Comal County Environmental Health OSSF Inspection Sheet

Permit of Authorization to Construct an On-Site Sewage Facility Permit Valid For One Year From Date Issued

Permit Number: 116655
Issued This Date: 10/04/2023
This permit is hereby given to: HAVENBROOK HOMES OF TEXAS, LLC

RE: Septic Design #116655
834 Ledgeview Drive
Scenic Heights, Unit 2, Lot 264
Spring Branch, TX 78070
Havenbrook Homes

OWNER: HAVENBROOK HOMES		DRAWN BY: EJS III	
STREET ADDRESS: 834 LEDGEVIEW DRIVE			
LEGAL DESC: SCENIC HEIGHTS	UNIT/SECTION/PHASE: 2	BLOCK:	LOT: 264
PREPARED BY: GREG W. JOHNSON, P.E. F#002585	SCALE: 1"=20'	DATE: 1/21/2021	2nd REVISION: 2/28/2024

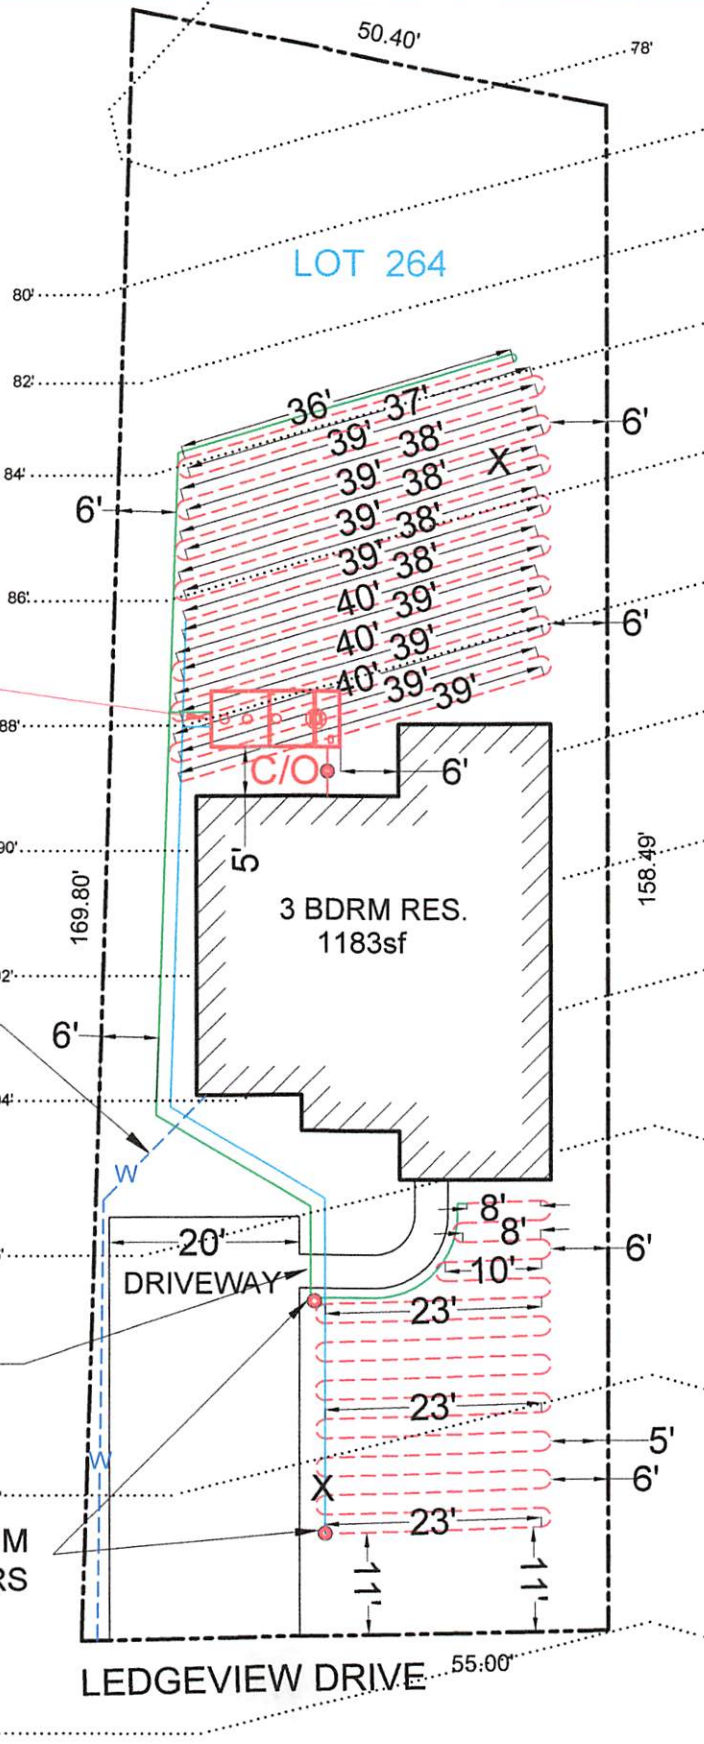
A portion of the waterline is five feet from the proposed drip field. A variance is required to Chapter 285 Table X & 290.44(e)(8). Equivalent protection will be maintained by sleeving the entire water service line with SCH-40 PVC within ten feet of the proposed drip field. I hereby request a variance to Chapter 285 Table X & 290.44(e)(8).

Revised waterline location.

SLEEVE WATER LINE WITH 2"-SCH-40 PVC PIPE WHEN ENTERING CLOSER THAN 10' FROM SEPTIC SYSTEM OR SEPTIC FIELD WHICH COMPLIES WITH TAC 30 CHAPTER 290.44(e)(B)(i).

SLEEVE SEPTIC LINE WITH SCH-40 WITHIN 5' AND UNDER DRIVEWAY/SIDEWALK.

OWNER: HAVENBROOK HOMES		DRAWN BY: EJS III	
STREET ADDRESS: 834 LEDGEVIEW DRIVE			
LEGAL DESC: SCENIC HEIGHTS	UNIT/SECTION/PHASE: 2	BLOCK:	LOT: 264
PREPARED BY: GREG W. JOHNSON, P.E. F#002585	SCALE: 1"=20'	DATE: 1/21/2021	REVISED: 10/19/2023

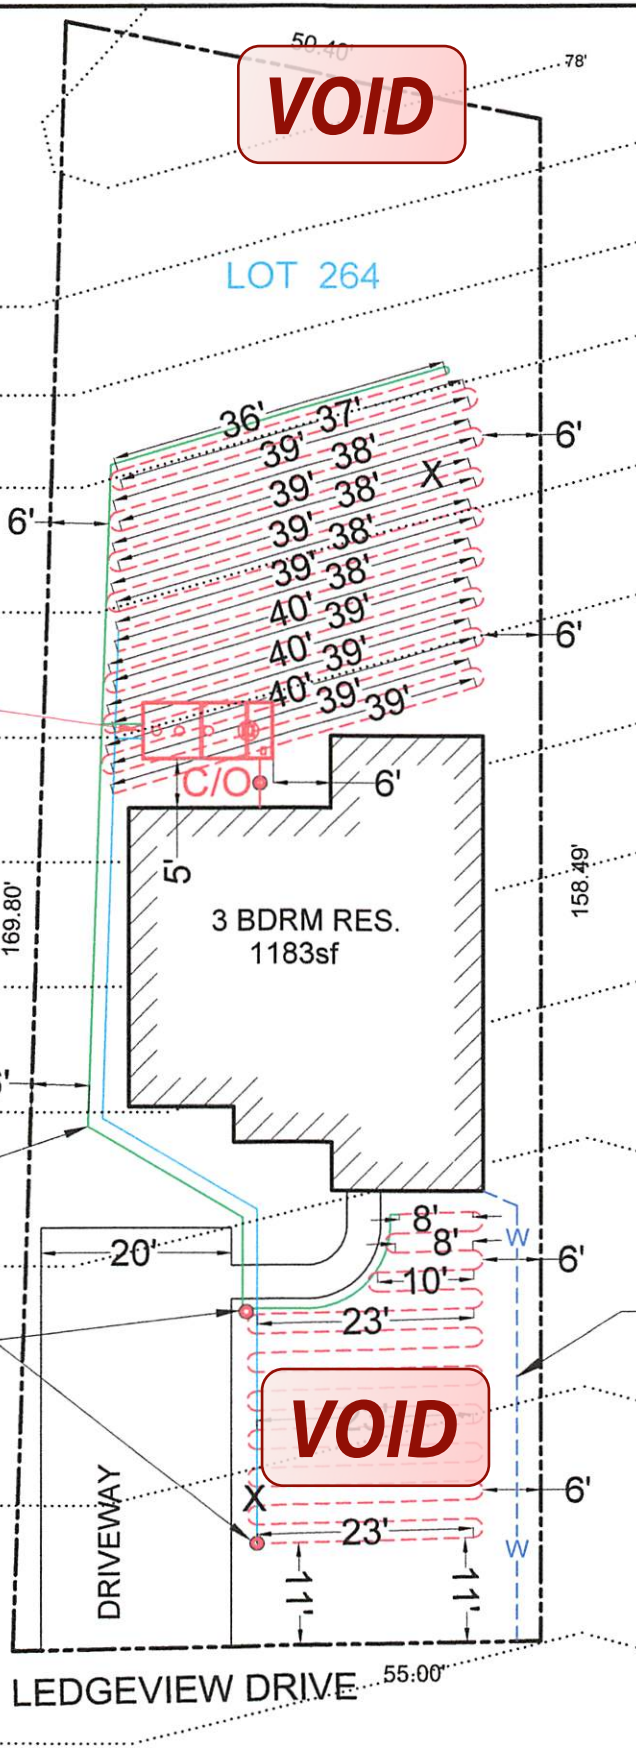
Revised drive and field layout.
Thanks,
Greg
